SUBJECT: TURKEY POINT NUCLEAR GENERATING, UNIT NOS. 3 AND 4 - STAFF
ASSESSMENT OF RESPONSE TO 10 CFR 50.54(f) INFORMATION
REQUEST - FLOOD-CAUSING MECHANISM REEVALUATION (TAC NOS.
MF1114 AND MF1115)

STAFF ASSESSMENT BY THE OFFICE OF NUCLEAR REACTOR REGULATION
RELATED TO FLOODING HAZARD REEVALUATION REPORT
NEAR-TERM TASK FORCE RECOMMENDATION 2.1
RELATED TO THE FUKUSHIMA DAI-ICHI NUCLEAR POWER PLANT ACCIDENT
TURKEY POINT NUCLEAR GENERATING, UNIT NOS. 3 AND 4
DOCKET NOS. 50-250 AND 50-251

Figure 3.2-1 Example of FLO-2D results, showing maximum water depths predicted in modeling of LIP Scenario A over the entire model domain. (Source: FHRR Figure 4-6)

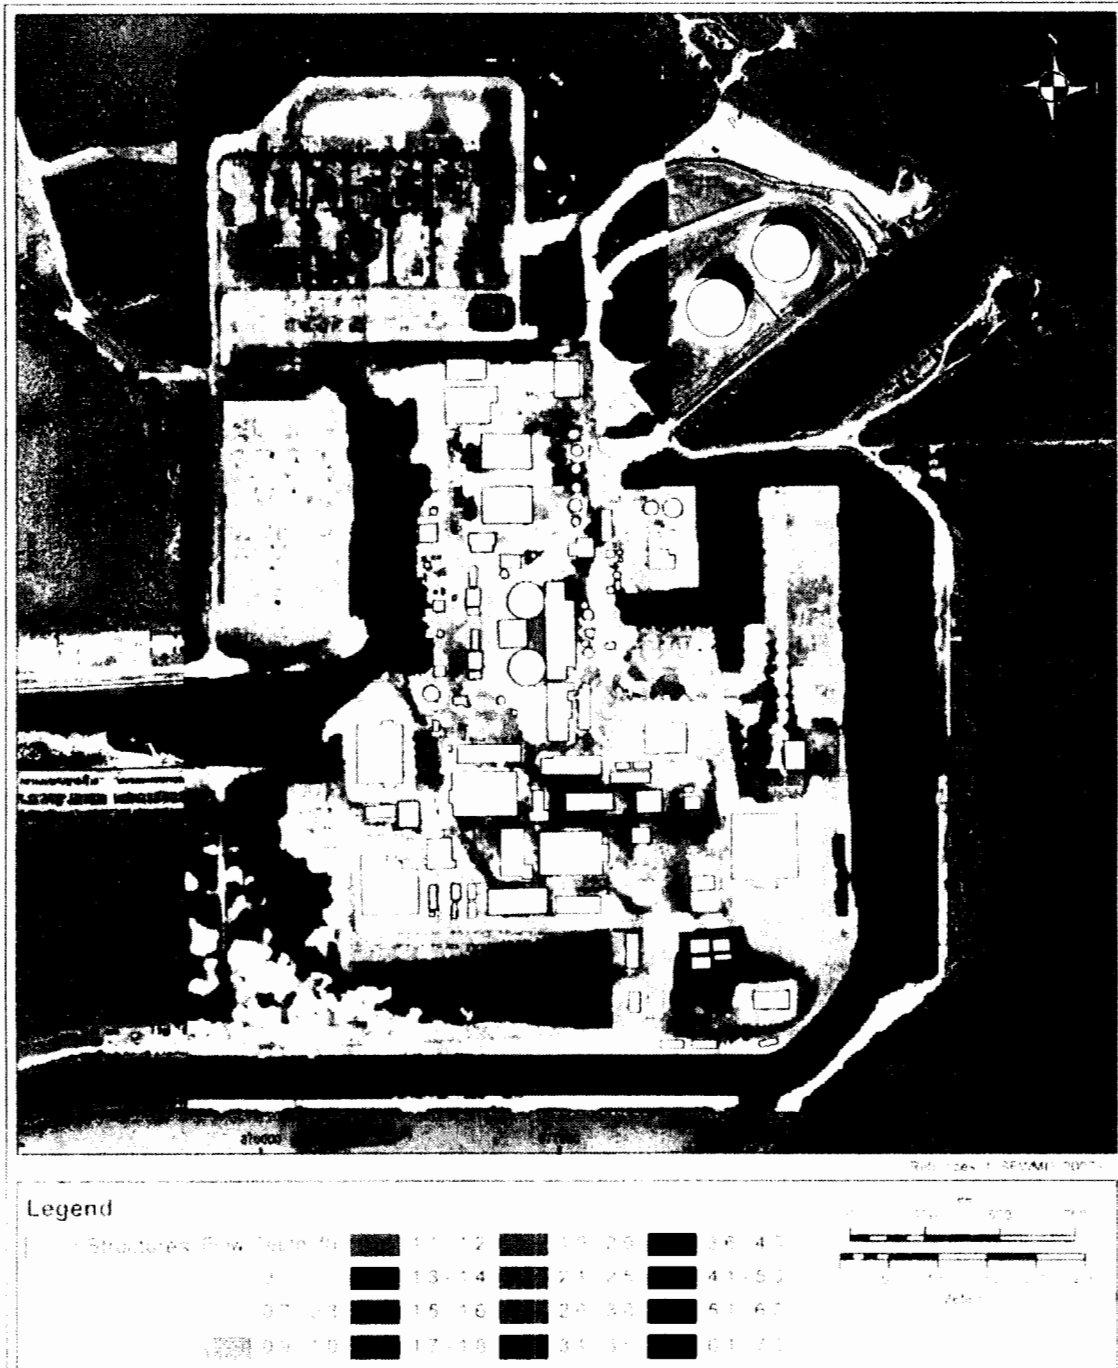
The licensee used FLO-2D to simulate the generation and flow of runoff from the one-hour PMP event, represented by applying the rainfall over the model grid at one-minute increments, as indicated in Table 3.2-2. Figures 3.2-1 and 3.2-2 illustrate the results of one model run for Scenario A. Figure 3.2-2 shows the locations of POIs. The licensee did not provide similar figures for Scenario B in its FHRR.

The staff reviewed details of the licensee's FLO-2D model implementation and determined that the approaches and assumptions were conservative. The model output files reviewed by NRC staff did not report any errors related to model stability or mass balance. Additionally, staff performed confirmatory analysis using FLO-2D with one of the licensee's input data sets and confirmed the licensee's results.

Figure 3.2-2 Locations of numbered points of interest⁽¹⁾, with maximum water depths predicted in one FLO-2D model run for LIP Scenario A. (Source: Modified from FHRR Figure 4-7)

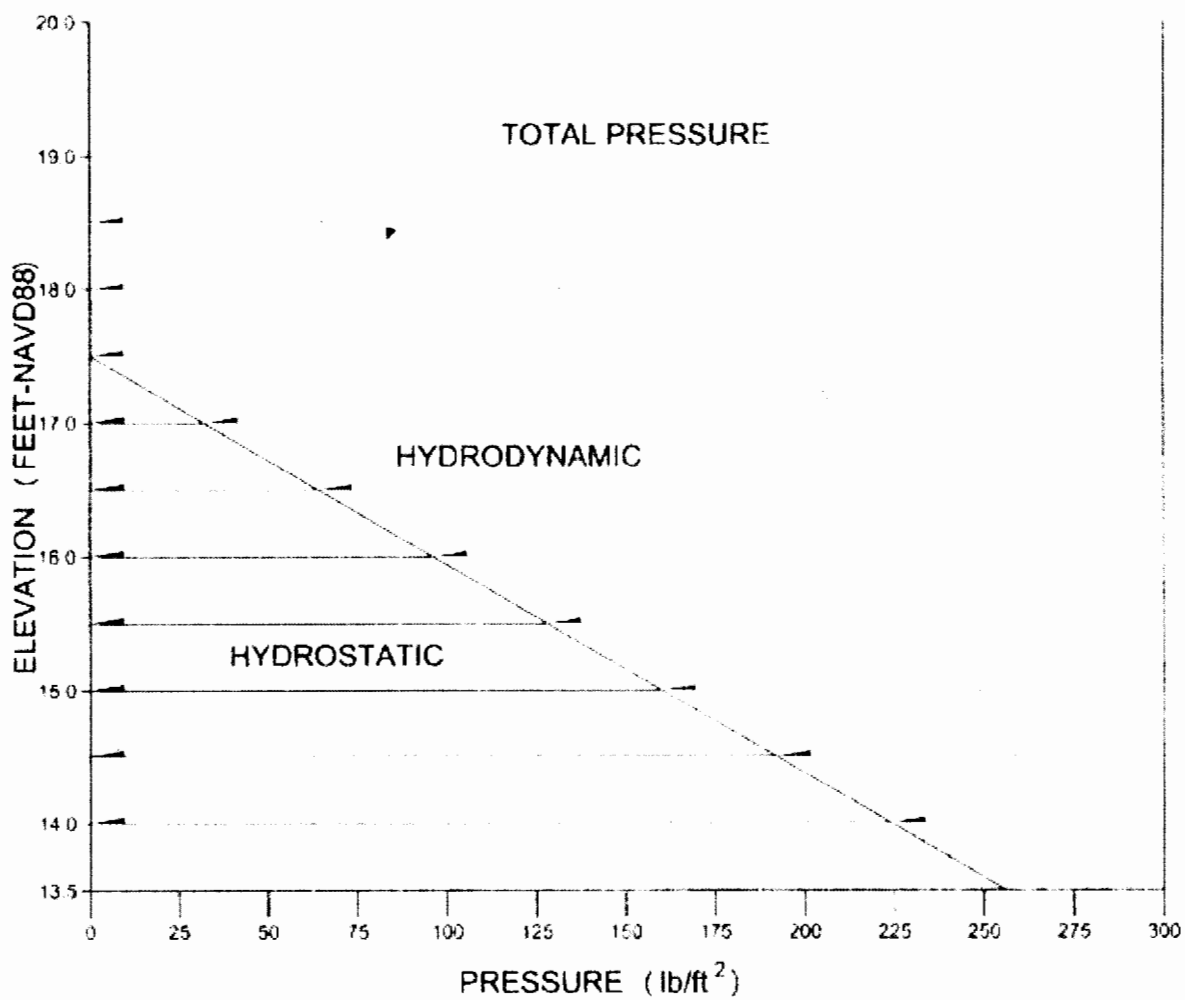
For LIP Scenario A, the licensee reported maximum flood water depths and elevations at 33 POIs; the greatest depth of water (above ground surface) at a POI location is reported as 1.7 ft

(0.5 m), corresponding to elevation 17.2 ft (5.2 m), for a POI in the CCW3 Area. For LIP Scenario B in CCW3, the licensee's letter indicates a peak water depth of 5.0 ft (1.5 m); for CCW4 the peak water depth was 1.3 ft (0.4 m). The corresponding water surface elevation for CCW3 was reported as 20.8 ft (6.3 m). The licensee stated that the revised peak water level in CCW3 exceeded the peak levels previously reported for LIP Scenario B and "was found to challenge SSCs" in that area. The licensee stated that it would implement interim actions to block runoff into the CCW areas before the hurricane season and that it had entered the revised flooding results for the CCW area and the need for interim actions into its corrective action program.
